RFP #2024-07

ADDENDUM #02

RFI #1

Operations Office

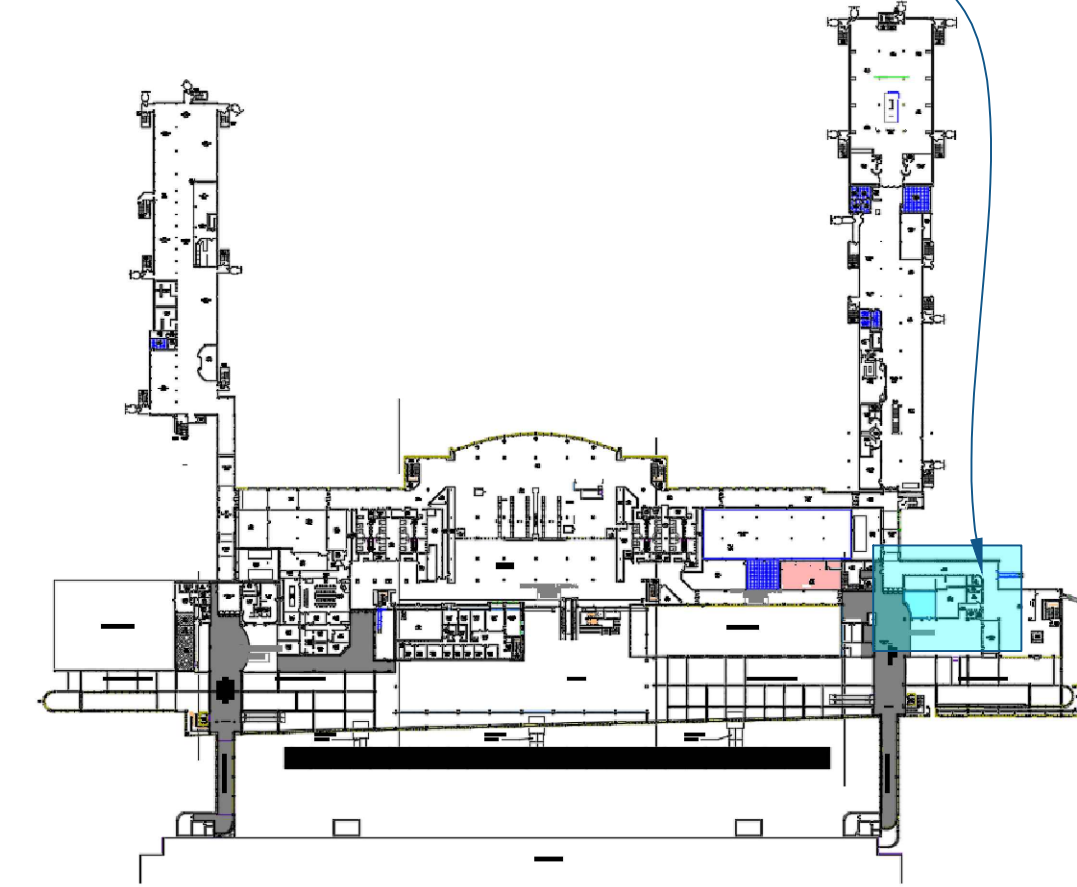
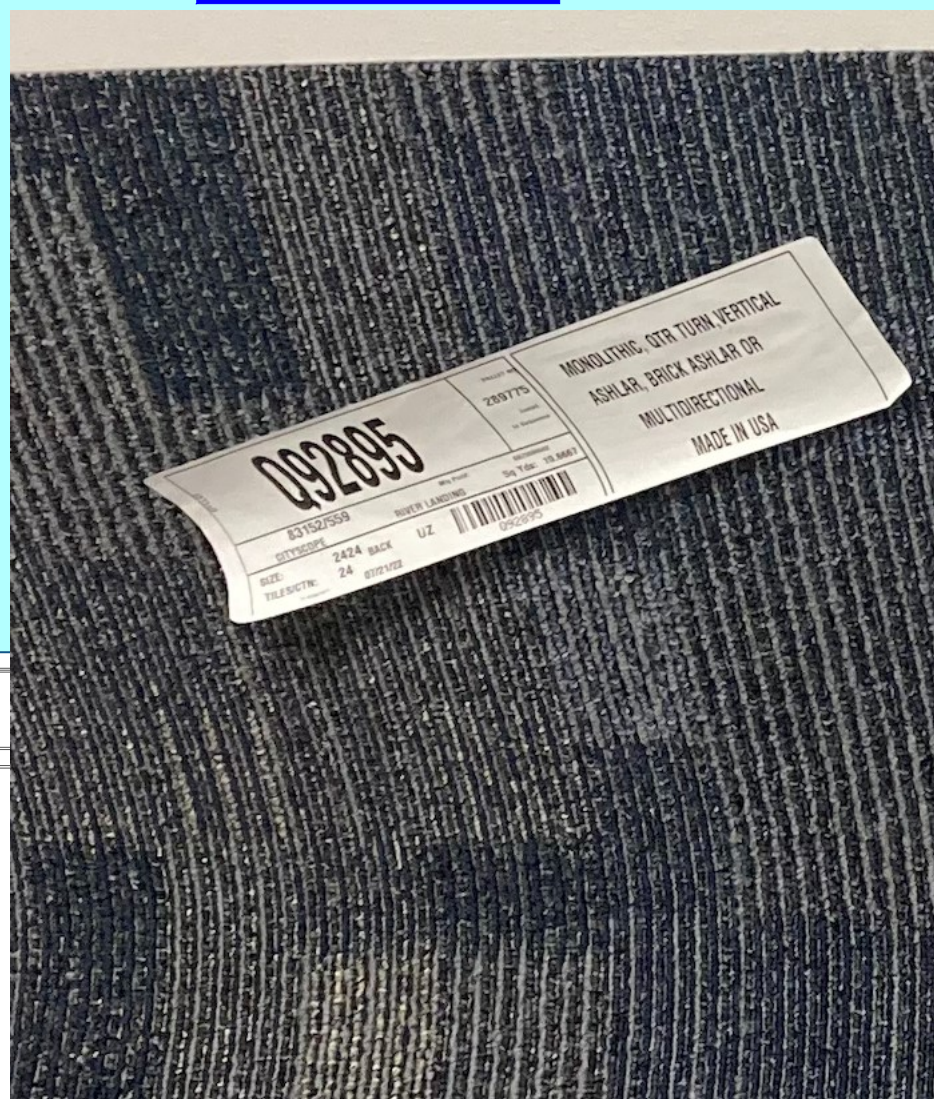
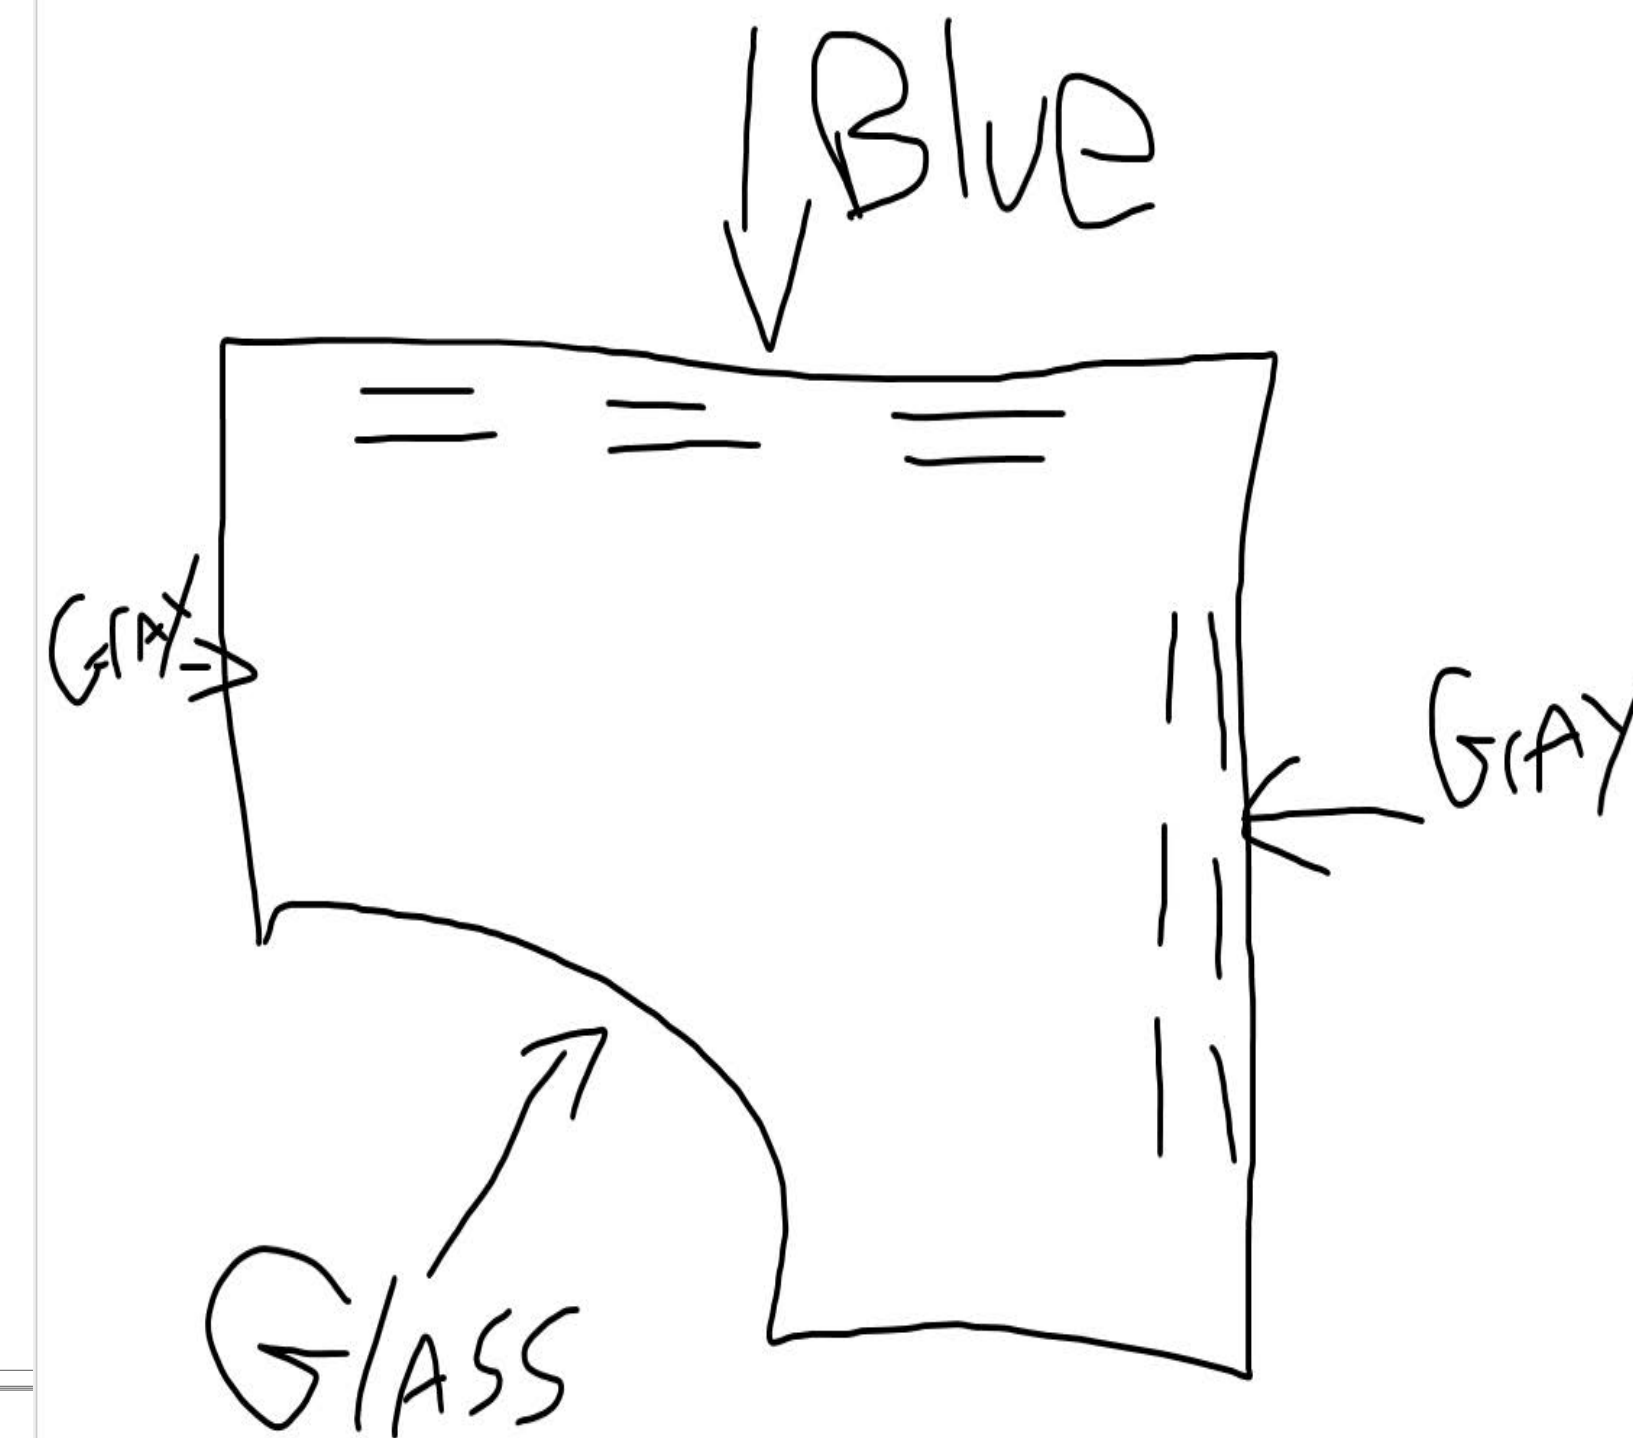
Please provide a laminate spec for P-LAM

A203 / A3 note #1 - Please provide Material specifications for the flooring, base, and paint.

Please provide manufacturer, model, and color of All Carpet & Wall Base to match existing adjacent OPS CENTER as listed on DWG A-203 finish schedule

See attached Exhibit.

Paint colors to be provided by Nuair. I believe we have this from the last build. Nicco is looking at past cut sheets. As well as carpet & paint.

Provided within the addendum.

Paint Scheme/Layout Provided below. Gray on North South Walls
Blue on East Wall.
Carpet material and all information below.
JSS 8.10.23
